No. 1145  
ATA Code 32-10

**SUBJECT:** LANDING GEAR - INSTALLATION OF AN IMPROVED MAIN LANDING GEAR SIDE BRACE SPRING PIVOT ASSEMBLY AND BUSHING

**EFFECTIVITY:** BEEHCRAFT Duchess 76, serials ME-1 through ME-333.

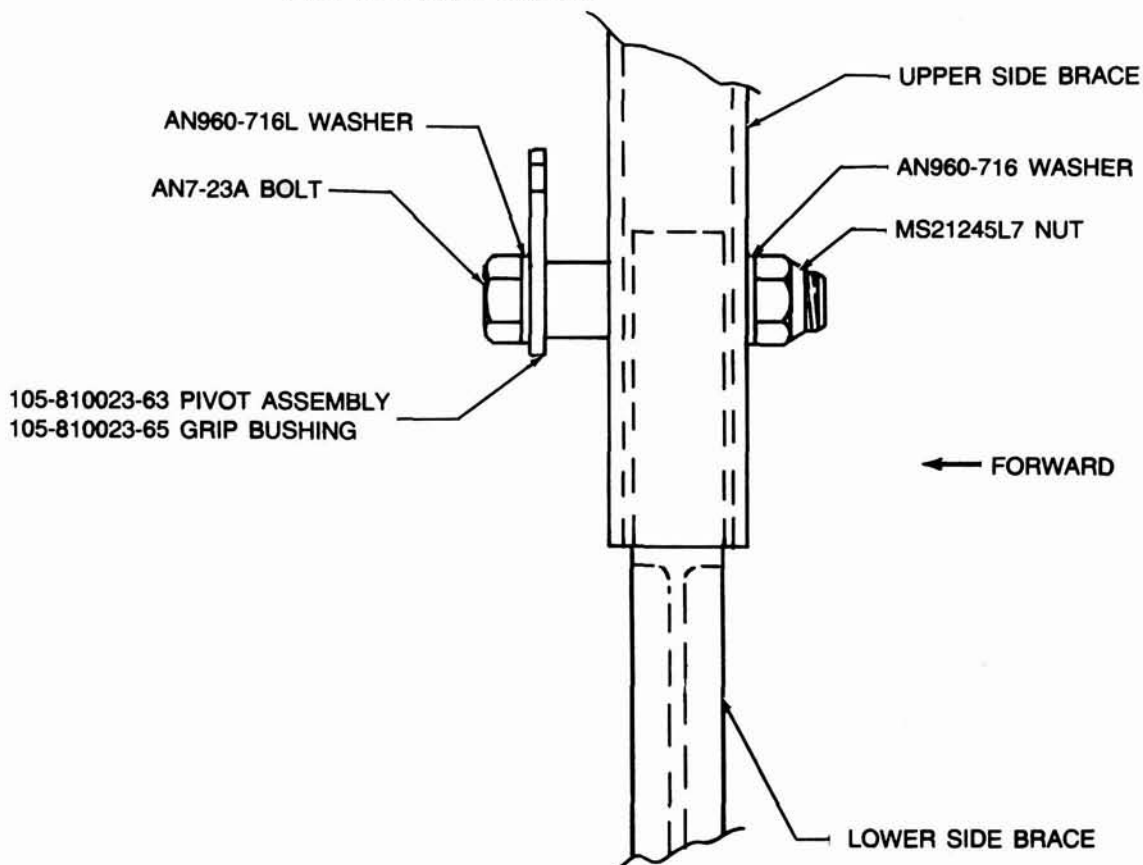
**REASON:** To provide an improved main landing gear side brace spring pivot assembly with a larger bearing surface to reduce excessive wear and the possibility of landing gear collapse.

3. Remove the main landing gear side brace springs.
4. Remove the pivot bolt which attaches the upper main landing gear side brace to the lower main landing gear side brace (see illustration).

5. Remove and discard the existing main landing gear side brace spring pivot and bushings from the pivot bolt (see illustration).
6. Install a P/N 105-810023-63 pivot assembly and P/N 105-810023-65 grip bushing on the pivot bolt as shown in the illustration.

7. Reinstall the pivot bolt in the upper and lower side braces using the hardware which was removed in step 4 and torque the bolt to 270-300 inch pounds.

8. Reinstall the main landing gear side brace springs between the new spring pivot assembly and the main landing gear fork.
9. Rotate the main landing gear fork aft and reinstall the four bolts which attach the shock absorber to the main landing gear housing.
